**RE: Proposed Water Supply Project:
American Natural Gas, Inc.
Alledonia, Belmont County, Ohio**

DOGRM engineers have reviewed the submitted plans for the American Natural Gas, Inc. proposed water transfer facility. Furthermore, two DOGRM engineers visited the site for the proposed facility. Based on the engineer's review of the plan and their site visit, there are significant weaknesses in the proposed plans for the facility and revisions need to be made in order to prevent environmental contamination and to receive an approval from the Chief. The engineer's required revisions consist of all of the following:

DOGRM engineers have reviewed the submitted plans for the Patriot Cambell proposed roll-off box wash facility. Furthermore, two DOGRM engineers visited the site for the proposed facility. Based on the engineer's review of the plan and their site visit, there are significant weaknesses in the proposed plans for the facility and revisions need to be made in order to prevent environmental contamination and to receive an approval from the Chief. The engineer's required revisions consist of all of the following:

ROLL OFF WASH BAY
SITE PLAN

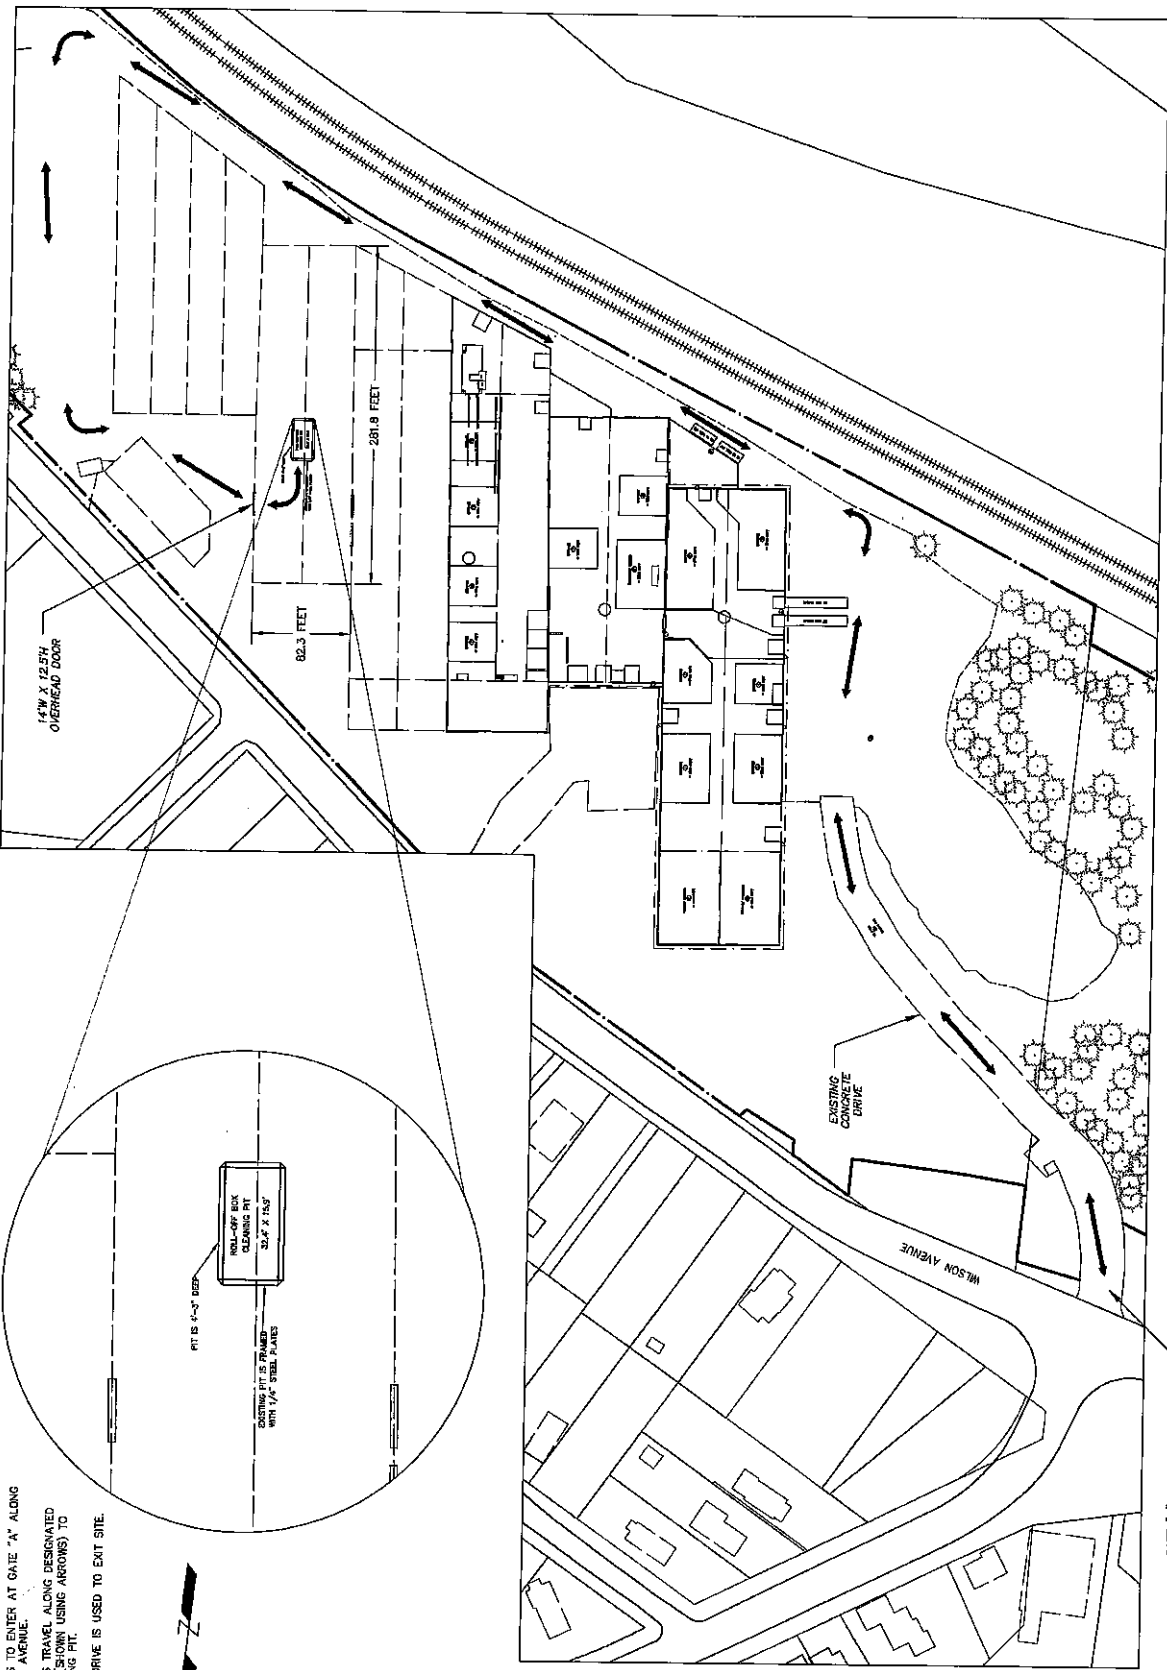
- Provide updated drawings showing proposed building footprint and other details pertaining to wash area, secondary containment for the facility, and staging areas for the boxes.

- Boundary of the proposed facility was not clearly identified.
- Provide details pertaining to ingress and egress from the building and traffic flow at the facility.

16" ANGLED 1/4" STEEL
SPRASH GUARD THAT
SURROUNDS THE PIT

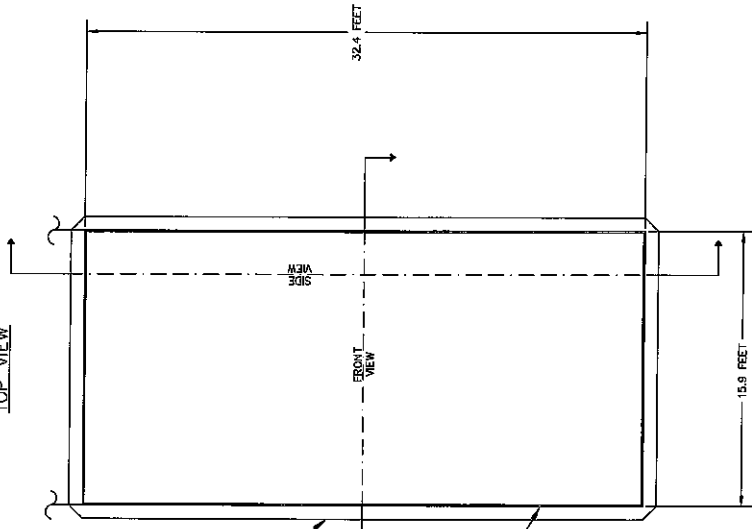
- Details need to be provided on the proposed pit modifications and splash guard, including sealing techniques for all penetrations into the pit, liner specifications, and containment and leakage controls.
